Haddam Neck Plant
Additional Information - Steam Generator Water Hammer

ADDITIONAL INFORMATION - STEAM GENERATOR WATER HAMMER

NRC REQUEST FOR ADDITIONAL INFORMATION ON STEAM
GENERATOR WATER HAMMER

FIGURE (1)

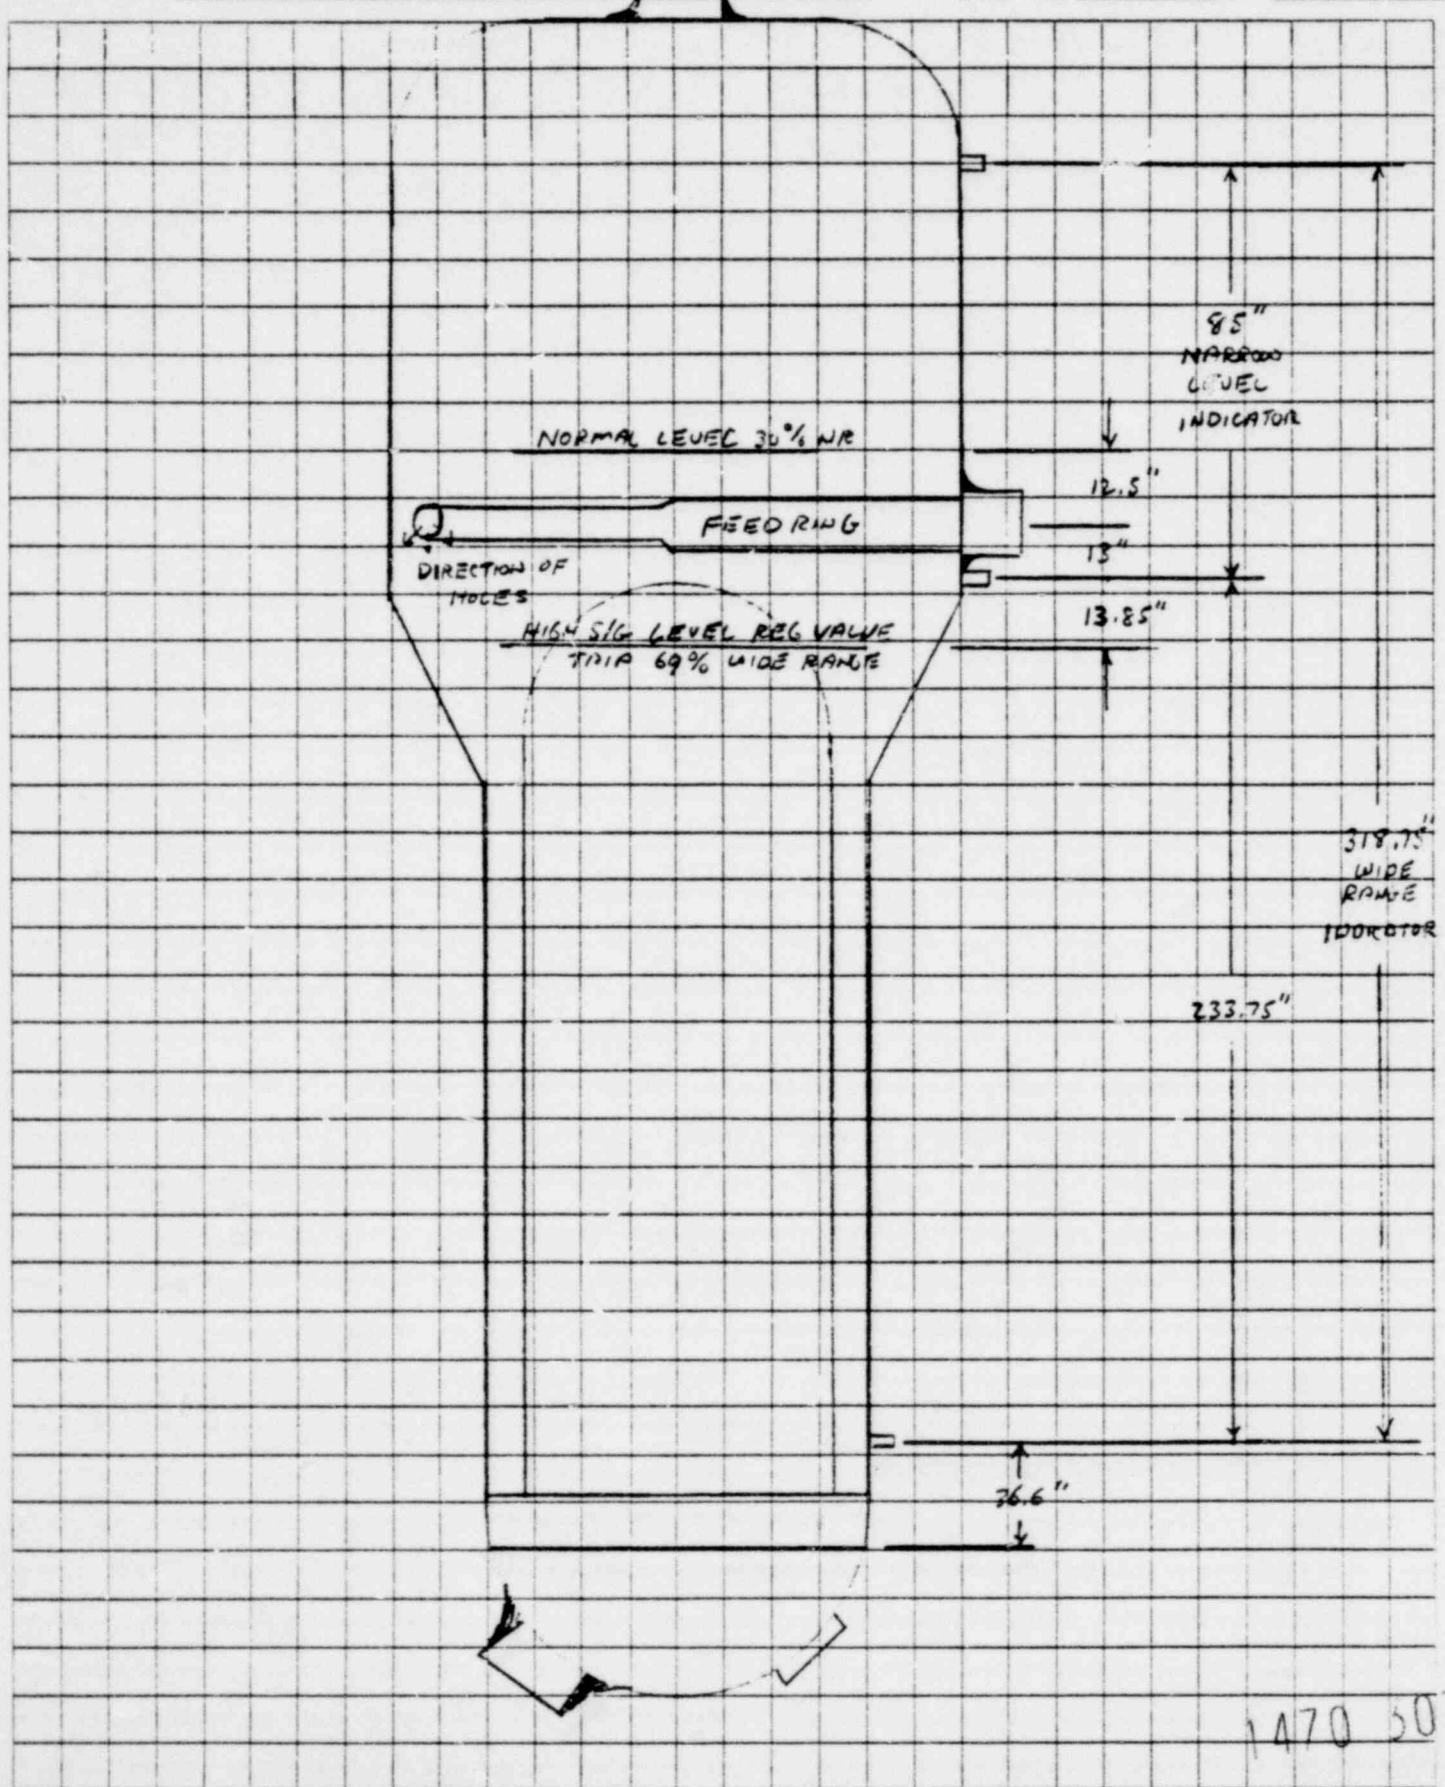
- 1.1 Describe the expected behavior of steam generator water level as a result of reactor trip from power levels greater than 30% of full power. Include actual plant measurements of steam generator level and other available data such as feedwater flow and auxiliary feedwater flow.

A layout of the location of the feedwater sparger in relation to the normal operating level is as shown in Figure (1). Each time a reactor trip occurs the steam generator level decreases below the narrow range capability which is below the feedwater sparger. The recovery of the steam generator level above sparger will normally take 5-20 minutes. In any event, the feedwater regulating valve will close off due to a reduced T_{avg} or high steam generator level (69% wide range). This isolation of feedwater from the steam generators will result in the feed ring draining until either the feedwater bypass valves are opened supplying main feedwater or the auxiliary feed pumps are manually initiated. The steam generator level is then manually brought up to normal (30% narrow range).

The normal decrease in steam generator level below the feedwater sparger coincident with the isolation of normal feedwater flow during a reactor trip demonstrates that the feedwater system has been subjected to those transient conditions which are conducive to water hammer. This also demonstrates the satisfactory ability of the plant to recover from these events with no major water hammers reported. Reference (1) also indicates that the existing feedwater piping adjacent to each steam generator remains full even if the steam generator sparger drains down. This will eliminate the possibility of immediately adding "cold" auxiliary feedwater to a steam sparger subsequent to a reactor trip.
